**To:** Kristopher Byrd, Well Construction and Compliance Section Manager  
**From:** Travis Kelly, Well Construction Program Coordinator  
**Subject:** Re-Review of Water Right Application G-18907  
**Date:** July 19, 2021

# Groundwater Application Review Summary Form

Application # G- 18907

PUBLIC INTEREST REVIEW FOR GROUNDWATER APPLICATIONS

**D. WELL CONSTRUCTION, OAR 690-200**

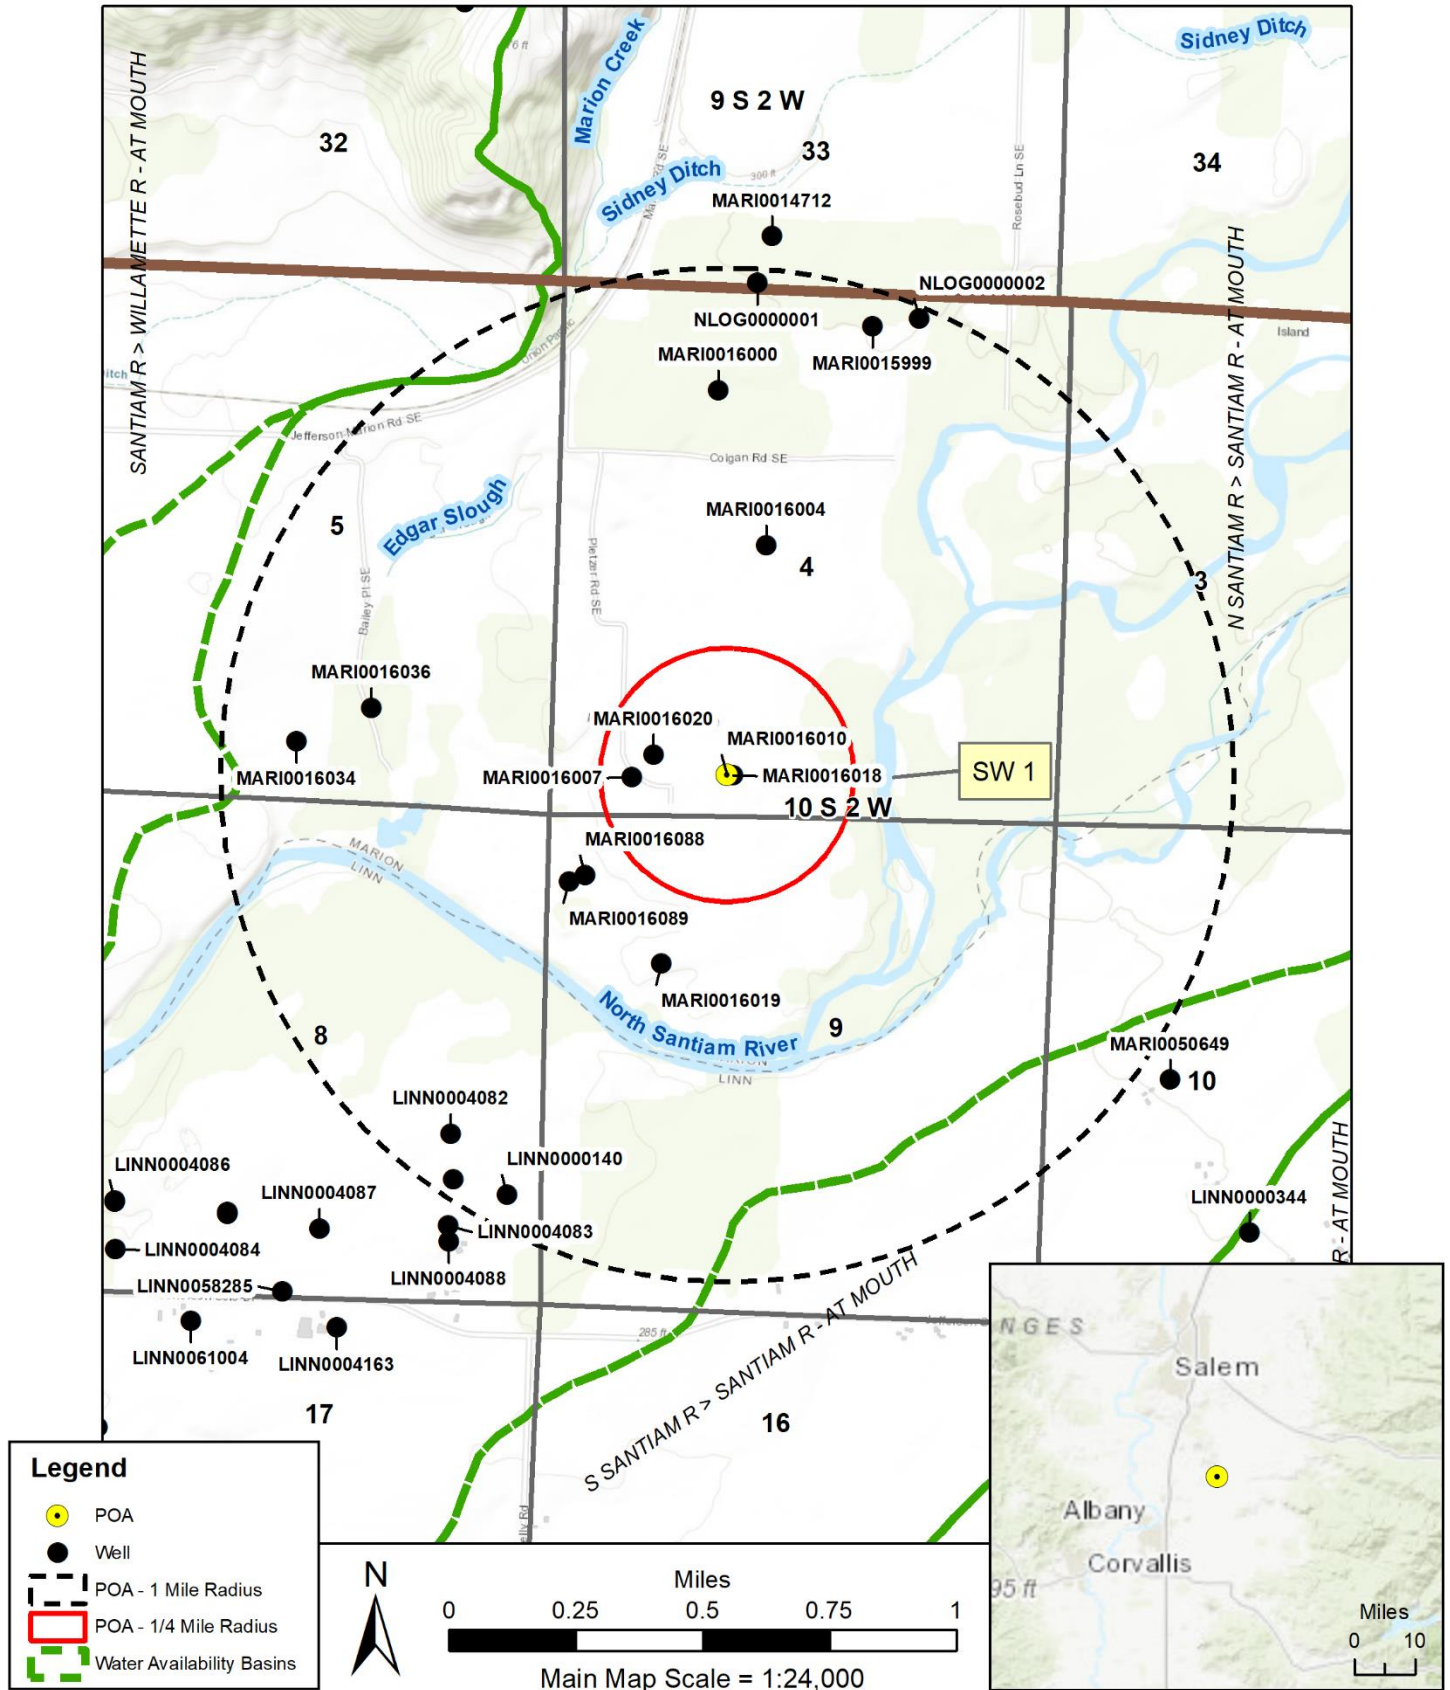
Applicant's Well #1 (MARI 16010): Based on the original review of the Well Report, Applicant's Well #1 did not appear to comply with current minimum well construction standards (See OAR 690 Division 210). The problem was that the Well Report indicates that the well head is flush with land surface. In order to meet minimum well construction standards, the well construction and compliance section (WCC) provided that the well head must be extended so that it is at least one foot above land surface. Because of this deficiency, WCC previously found that the well would need to be reconstructed in order to meet minimum construction standards.

Since WCC's previous review, the applicant has reconstructed the floor of the pump house surrounding the well, lowering it one foot below the top of the well head. Based on photos of the reconstructed pump house floor showing the well head extending at least one foot above the floor, WCC re-reviewed the construction of Applicant's Well #1 and has determined that the construction of Applicant's Well #1 seems to protect the groundwater resource.

D2. **THE WELL does not appear to meet current well construction standards based upon:**

D3. **THE WELL construction deficiency or other comment is described as follows:** \_\_\_\_\_  
\_\_\_\_\_  
\_\_\_\_\_  
\_\_\_\_\_

D4.  **Route to the Well Construction and Compliance Section for a review of existing well construction.**
